RFT 26-083 Interior Renovations & Air Conditioner Upgrades at Frontenac PS

The following, issued by the Halton District School Board (HDSB) June 18, 2026, shall be incorporated in the specifications and shall form part of the proposal document for the above.

TENDER ADDENDUM NO. 1
2026.06.17

Interior Renovations and Air Conditioner Upgrades at Frontenac Public School
Halton District School Board RFT 26-083
5140 Pinedale Avenue, Burlington, Ontario

Drawing No.:
A1.3

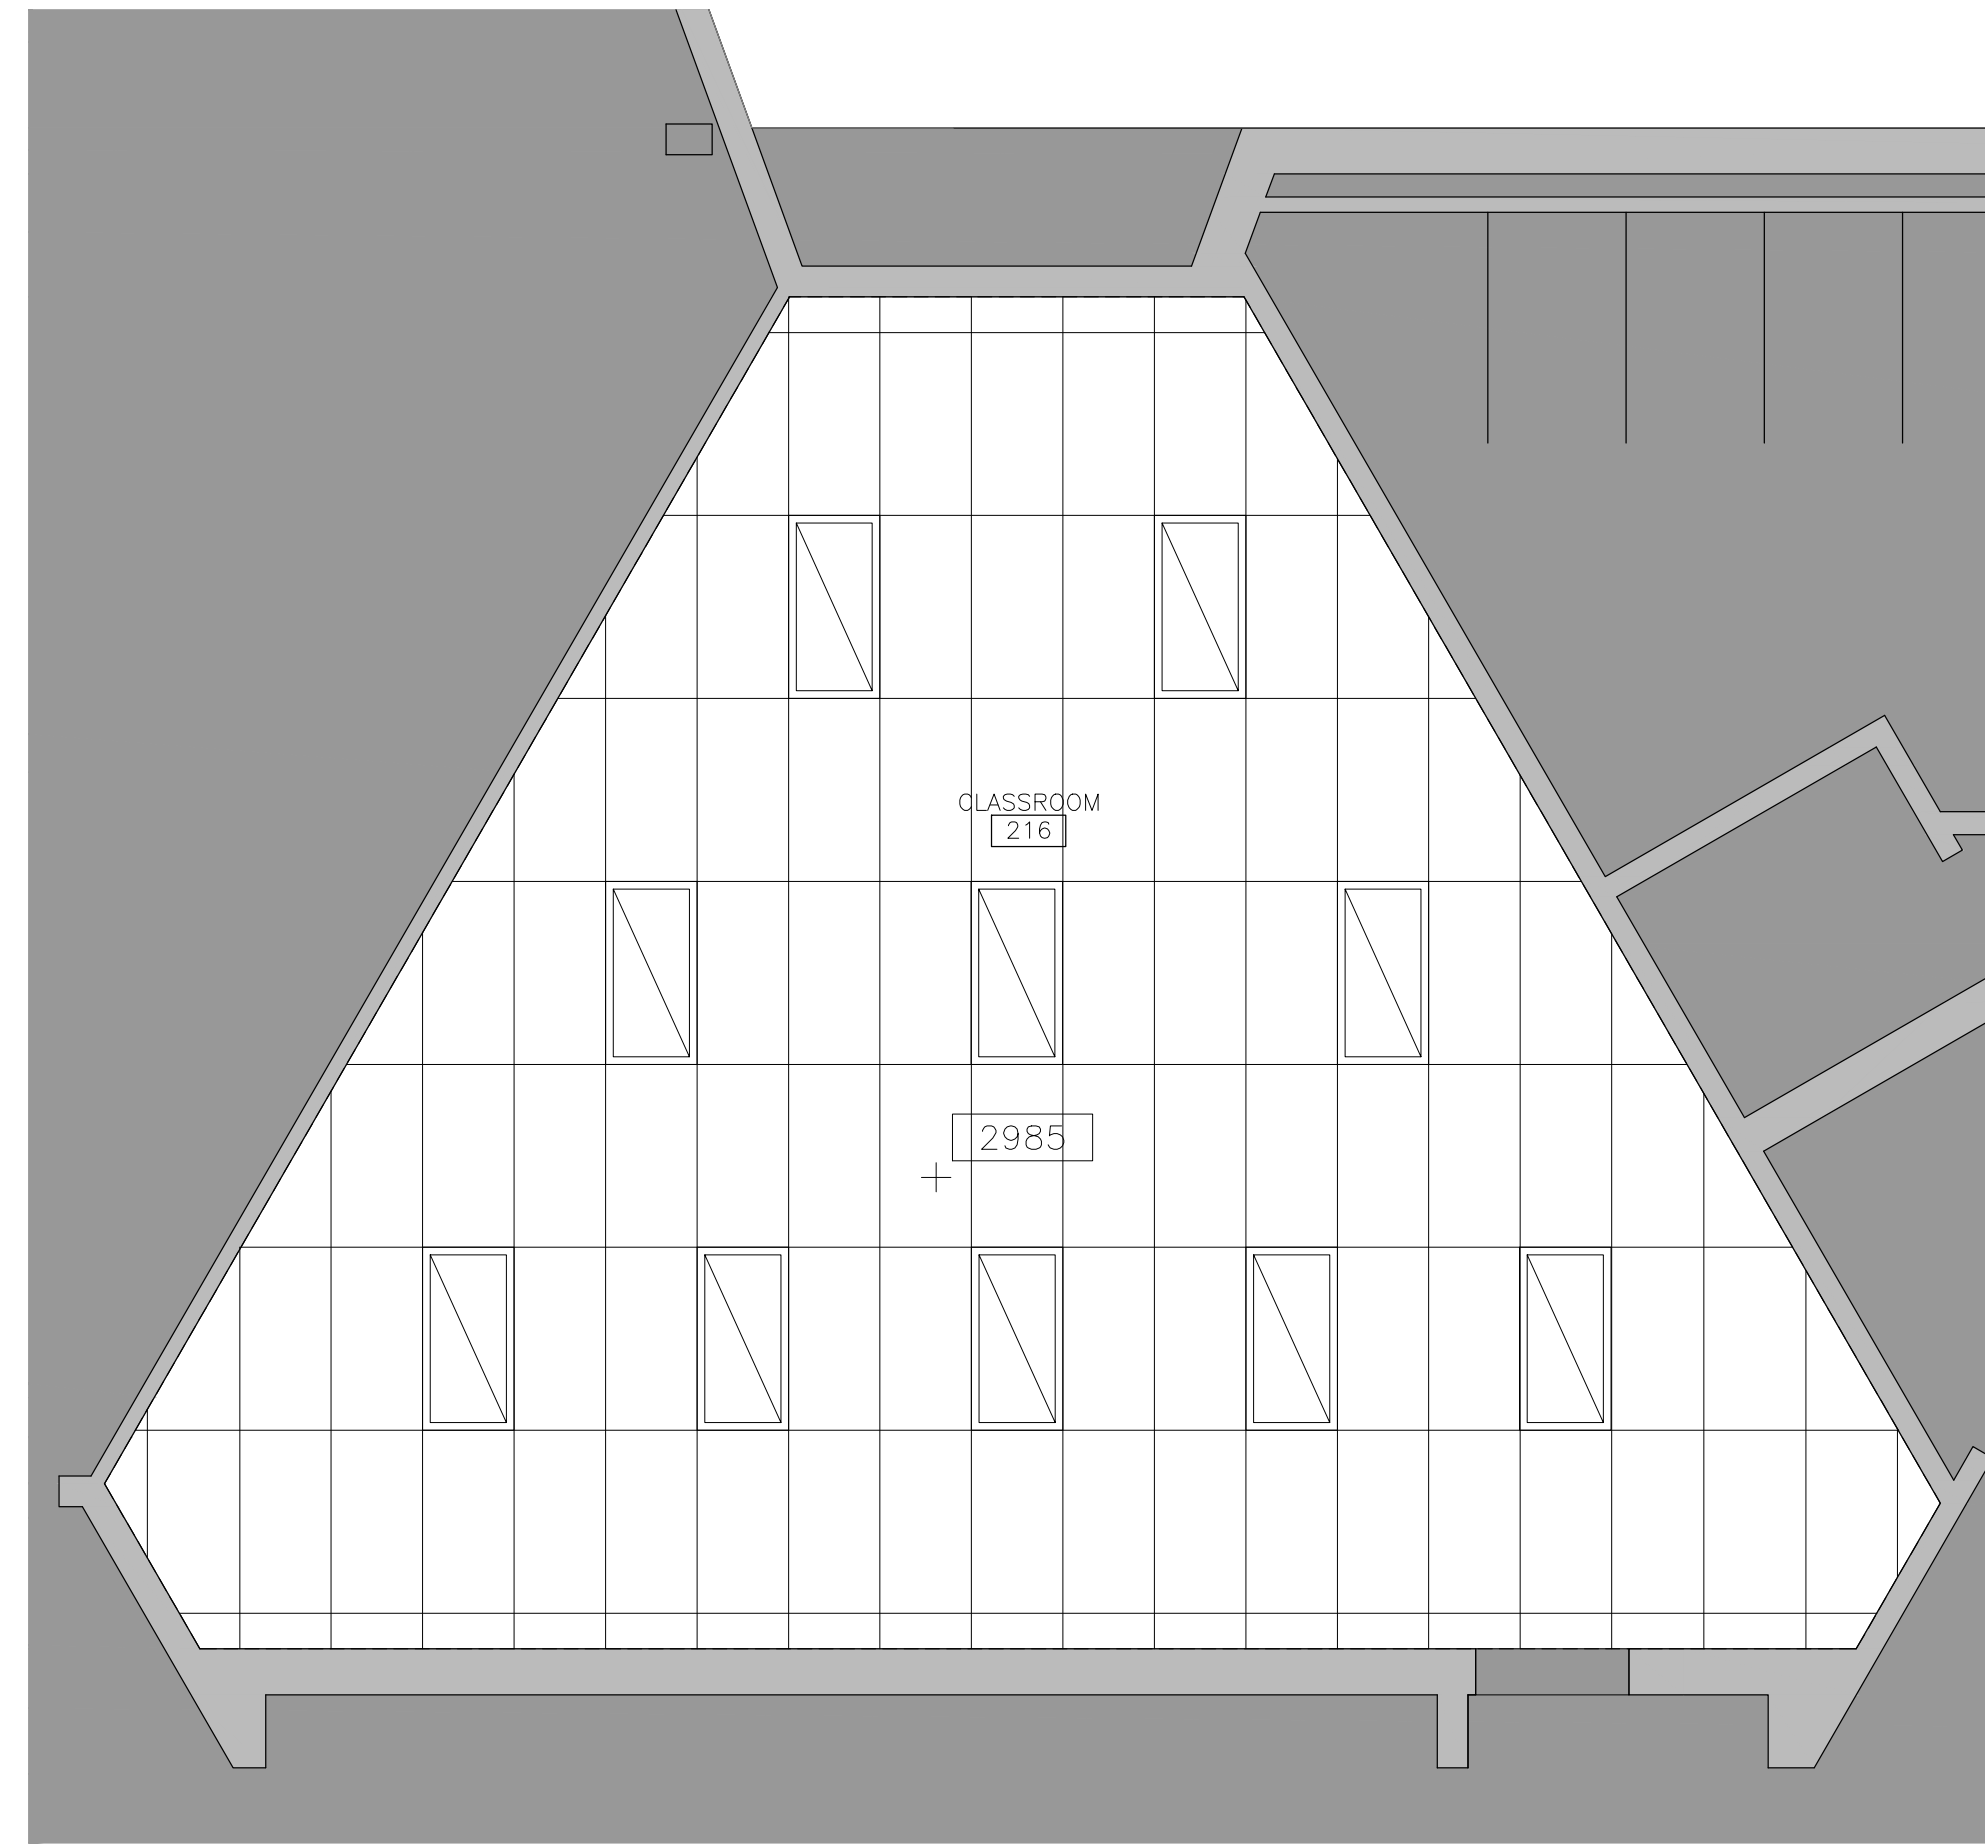
1.5: Drawing A1.3 Demolition & Proposed RCP:

1. ADD to Proposed Reflected Ceiling Plans 2/A1.3 and 4/A1.3 location of HVAC grilles and diffusers. See attached revised drawing A1.3 with bubbled revisions.

Drawing No.:
A1.4

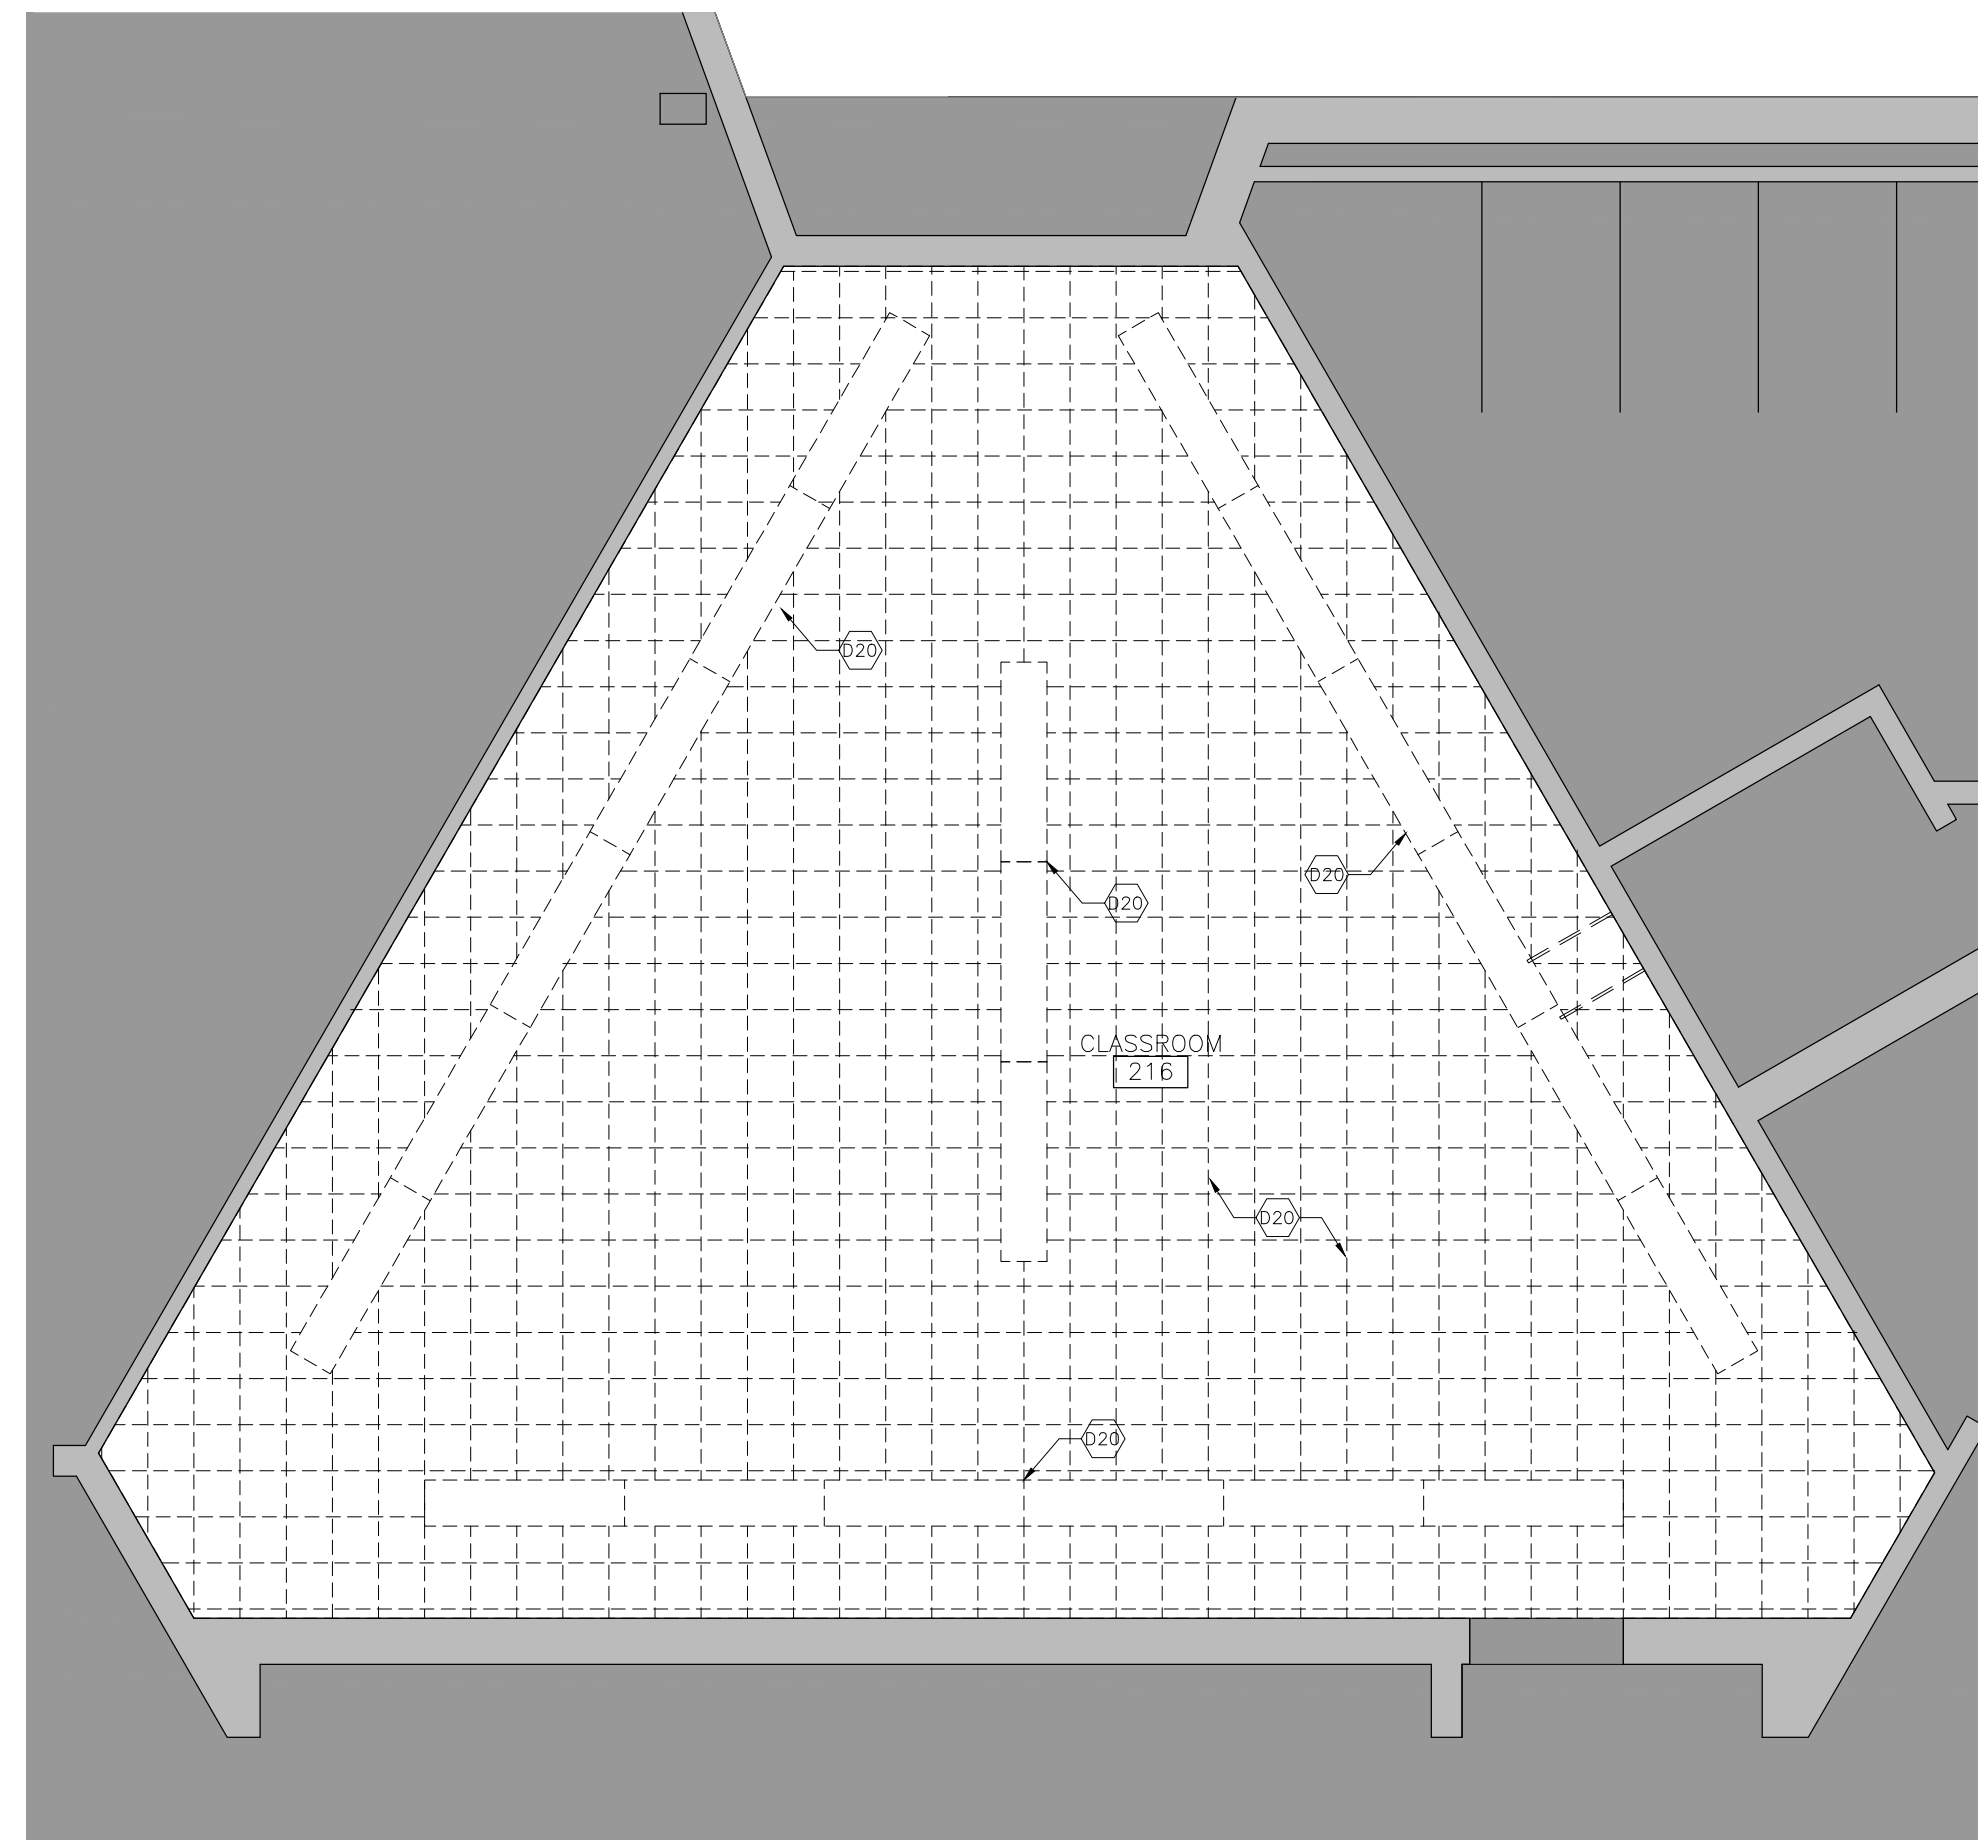
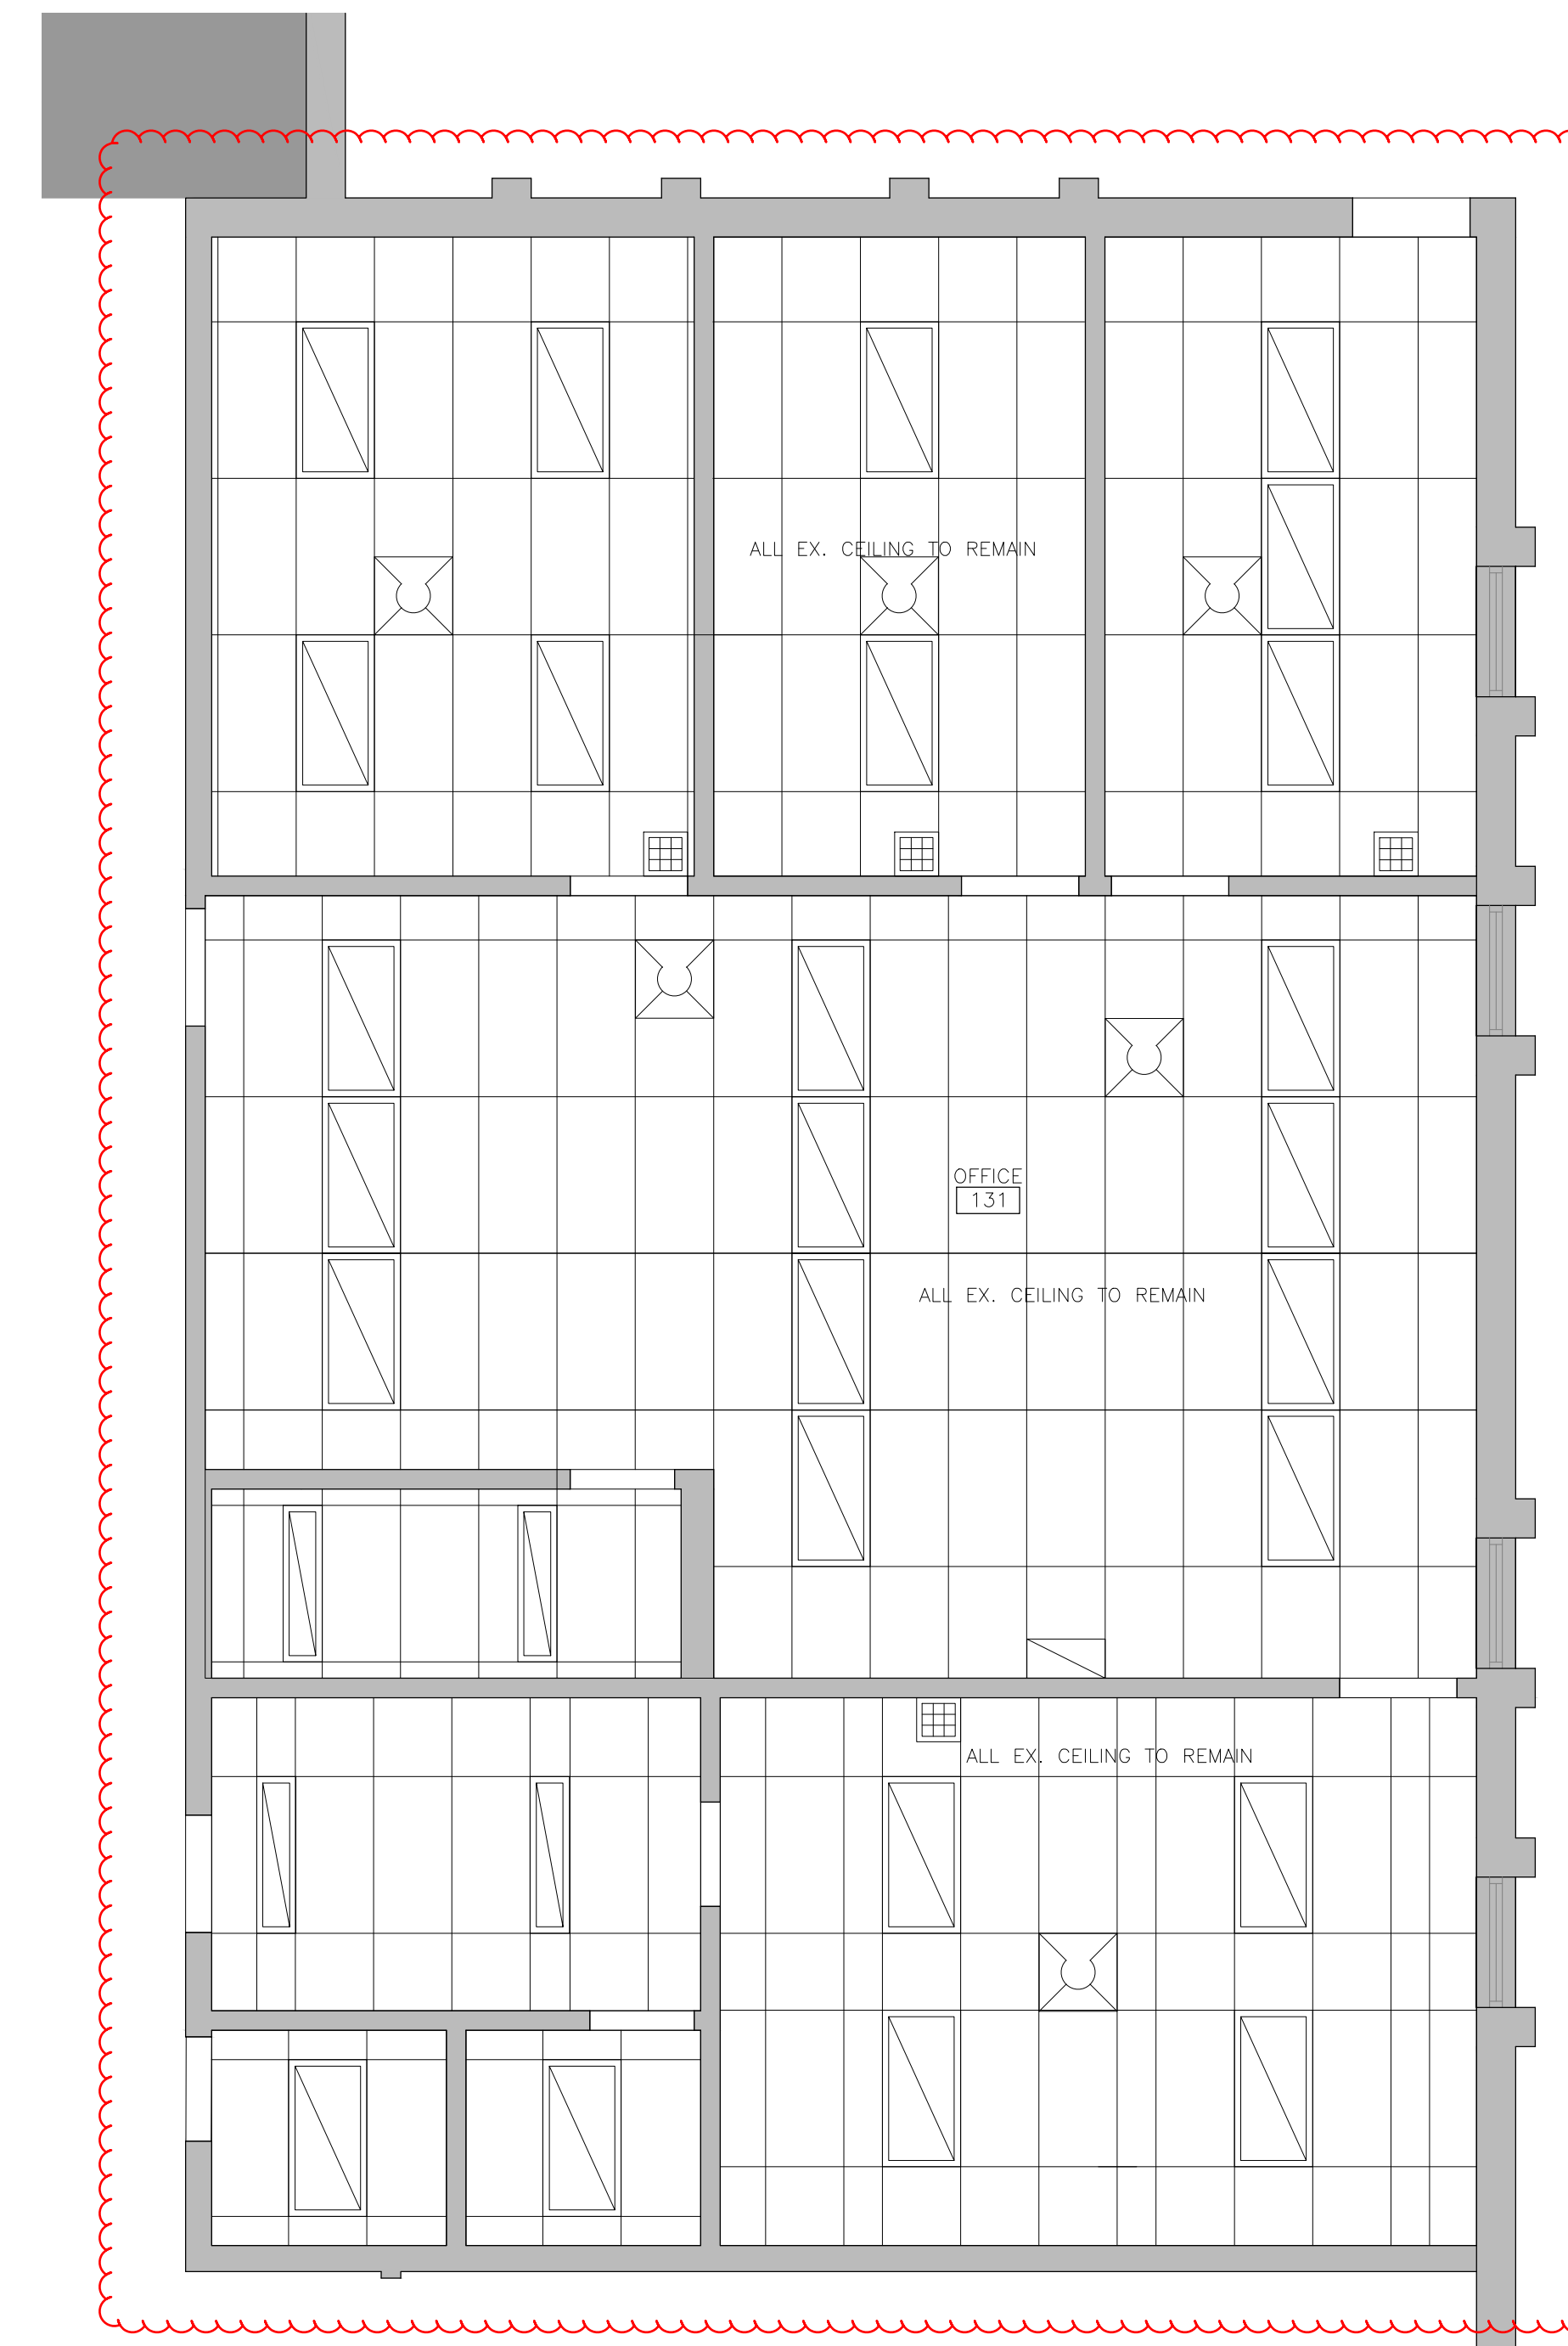
1.6: Drawing A1.4 RCP Office 131 & Second Floor 216:

1. ADD to 1/A1.4 Office 131 – Reflected Ceiling Plan location of HVAC grilles and diffusers and note that all lighting and suspended ceiling finishes are existing to remain. See attached revised drawing A1.4 with bubbled revisions.
